CCK-2617.0-11-25
UK Agriculture Research Facility 1 – BP06 Fitout Group 1
PROJECT # 2617.0
ADDENDUM # 4
01/15/2025

UK AG Research Building
BID PACKAGE – 06 Fitout
ADDENDUM No. 4
CCK-2617.0-11-25
1/15/2025

TCCO Addendum #4

E151

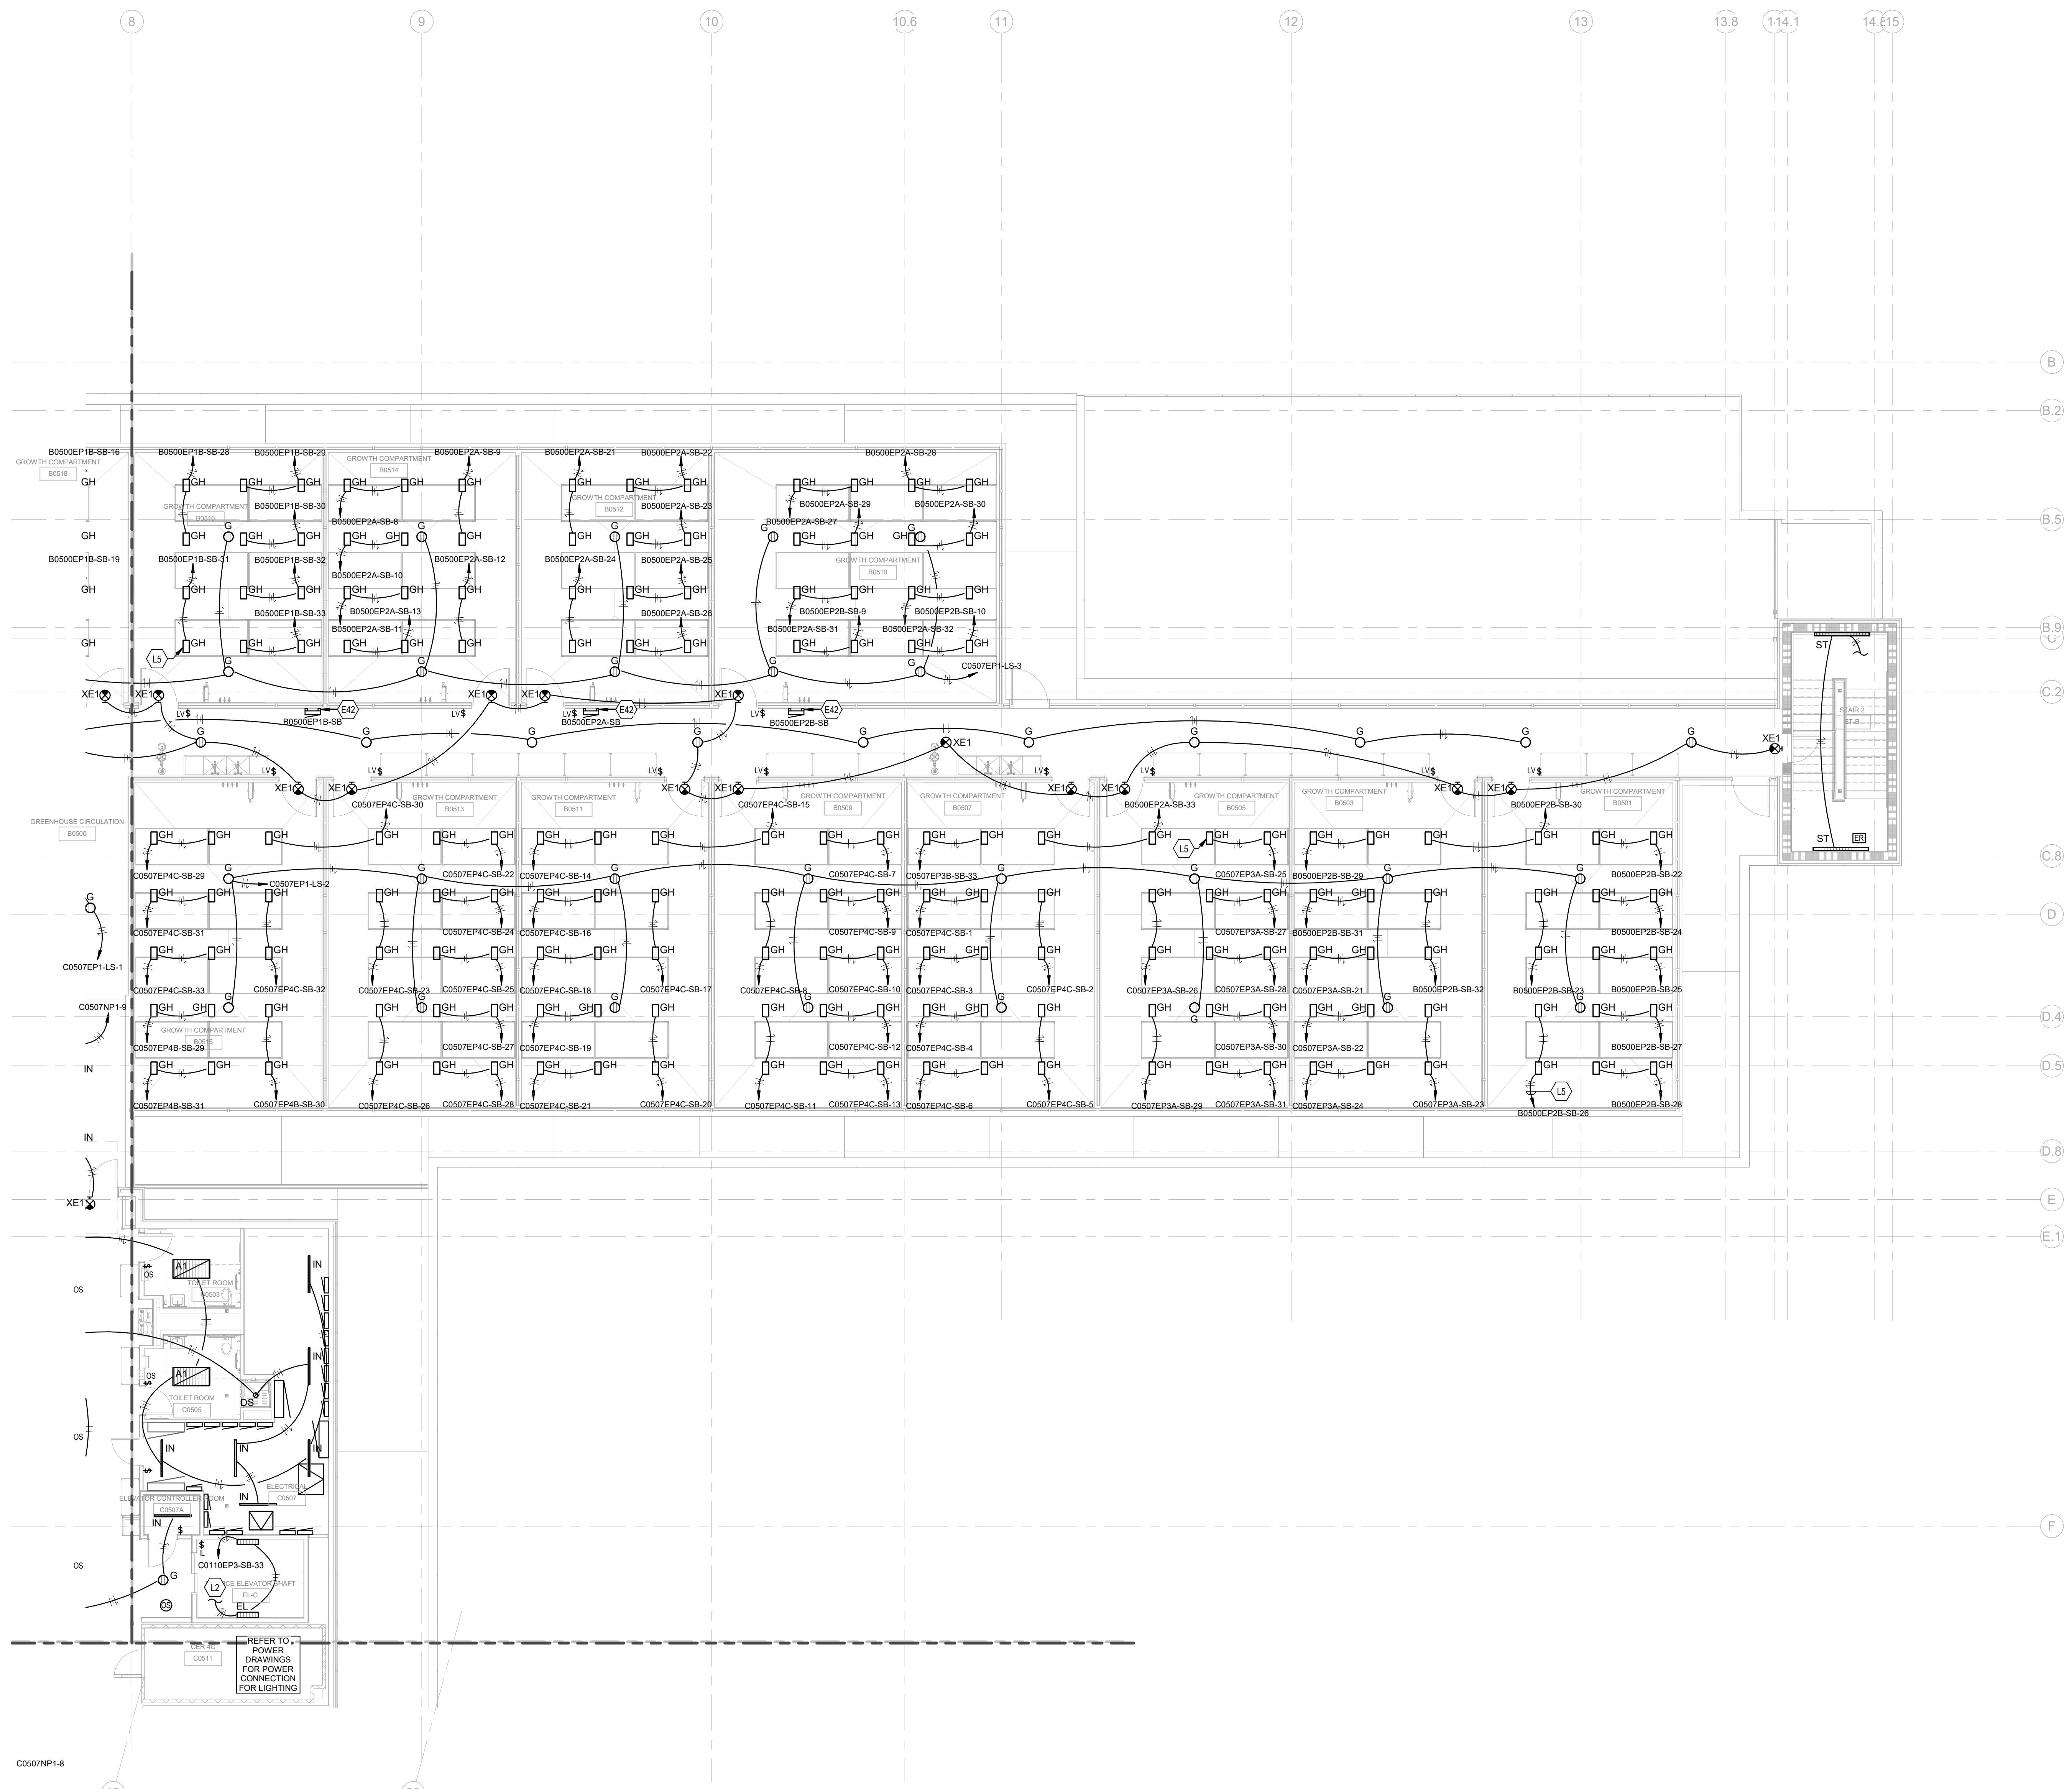
- b. Refer to sheet E600 "Responsibility Matrix" for more information.
- Item 4. E152 - GREENHOUSE FLOOR PLAN - LIGHTING - AREA 2
 - Added the following notes:

- Greenhouse Notes:
 - a. Refer to Greenhouse Vendor drawings. Provide all required low-voltage cabling/wiring and raceways to all devices.
 - b. Refer to sheet E600 "Responsibility Matrix" for more information.
